PROJECT NUMBER: 1010442 - 15DRB-70154 - SITE PLAN FOR BUILDING PERMIT

PROJECT NAME: DEL WEBB AT MIREHAVEN PHASE 1

PUBLIC AGENCY COMMENTS

15DRB-70154 – SITE DEVELOPMENT PLAN FOR BUILDING PERMIT

Site Plan for Building Permit
LANDSCAPE PLAN

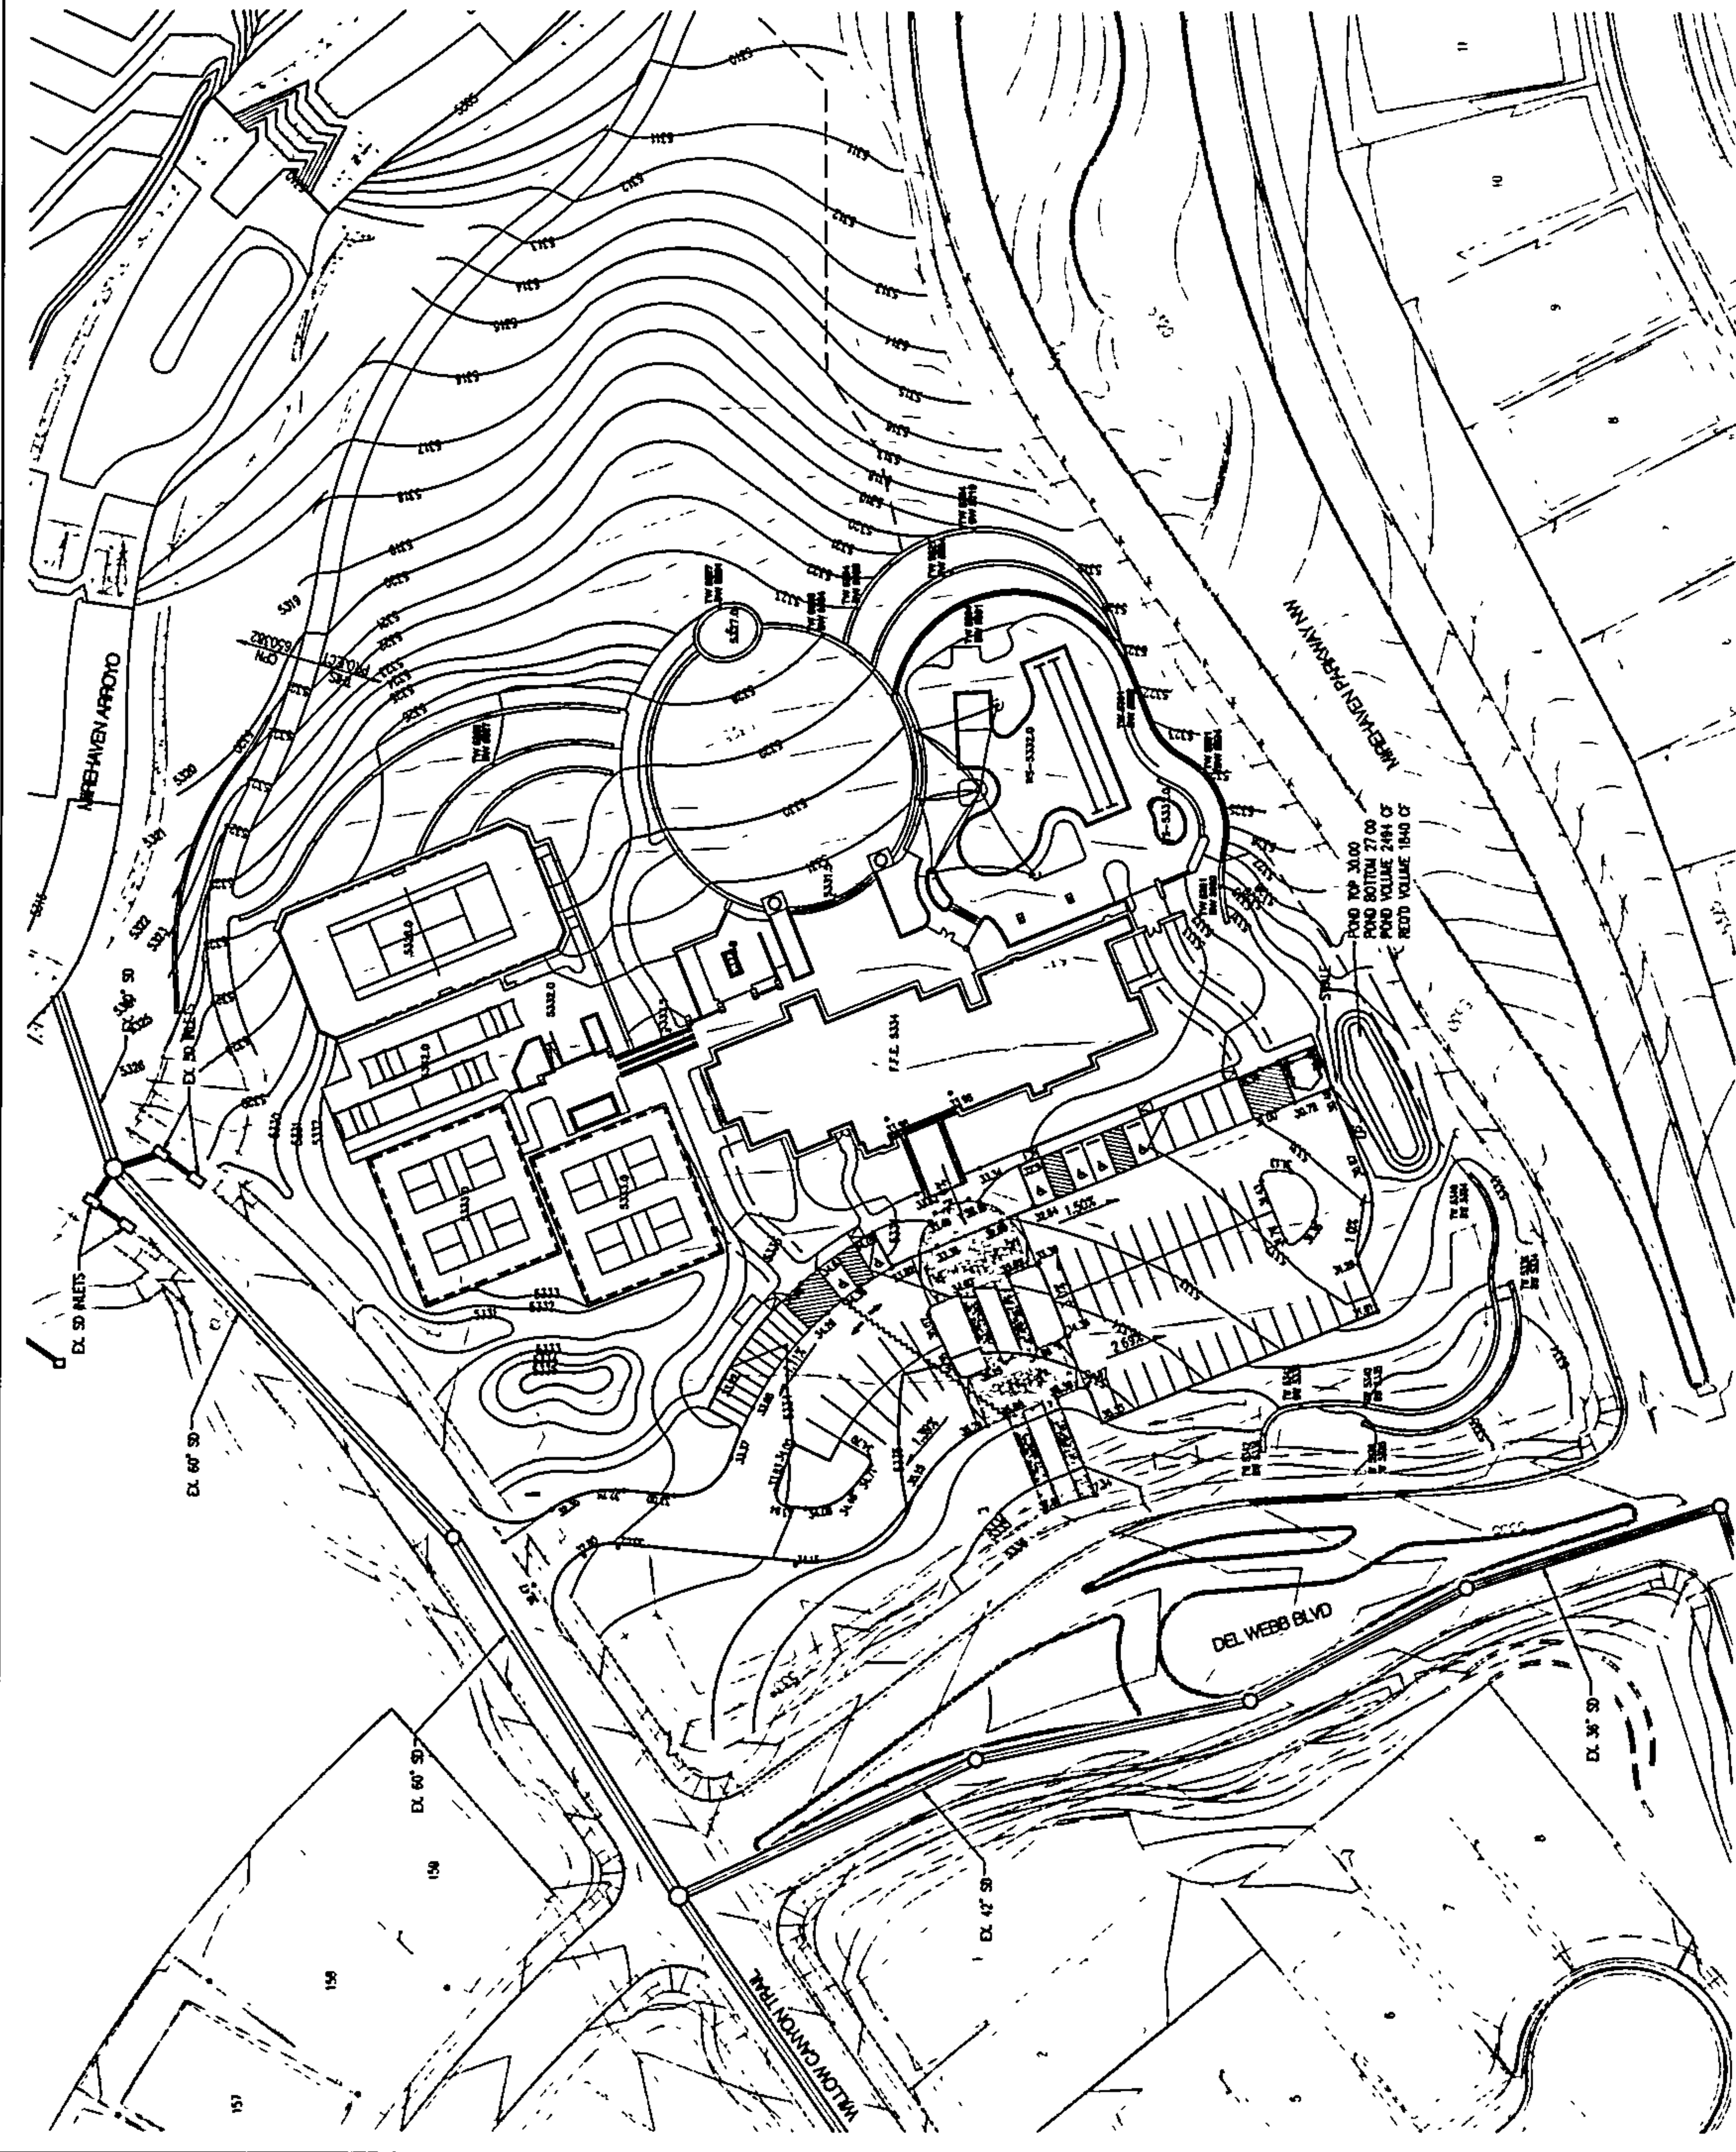
<p>PNM ELECTRIC <i>Daniel Aragon</i> Daniel.Aragon@pnm.com</p>	
<p>NEW MEXICO GAS COMPANY <i>Robert Gomez</i> Robert.gomez@nmgco.com</p>	
<p>COMCAST <i>Mike Mortus</i> Mike_Mortus@cable.comcast.com</p>	
<p>CENTURYLINK</p>	
<p>ENVIRONMENTAL HEALTH <i>Paul Olson</i> polson@cabq.gov</p>	
<p>M.R.G.C.D <i>Ray Gomez</i> michael@mrgcd.us</p>	
<p>OPEN SPACE DIVISION <i>Kent Reed Swanson</i> kswanson@cabq.gov <i>Sarah Brown</i> sbrowne@cabq.gov</p>	<p>As per the following plans regarding native vegetation use: West Side Strategic Plan (2014): Additional landscaping requirements will be developed as part of the design guidelines which will include a plant materials list for the West Side. These plants should be predominantly native to the upland mesa environment (p.171).</p> <p>Northwest Mesa Escarpment Plan Policy 13.2.a: Plants selected for landscaping on privately or publicly owned land shall be selected from the Plant Species List (Appendix D). Landscaping plans shall indicate a pattern that does not obscure major public views of the escarpment as defined in this document.</p> <p>According to the Watershed Subdivision Landscape Plan, Sheet 2 of 6, the landscape list includes several species such as the London planetree and the thorny locust that would not be considered native to the upland mesa environment. Please review plant list.</p>
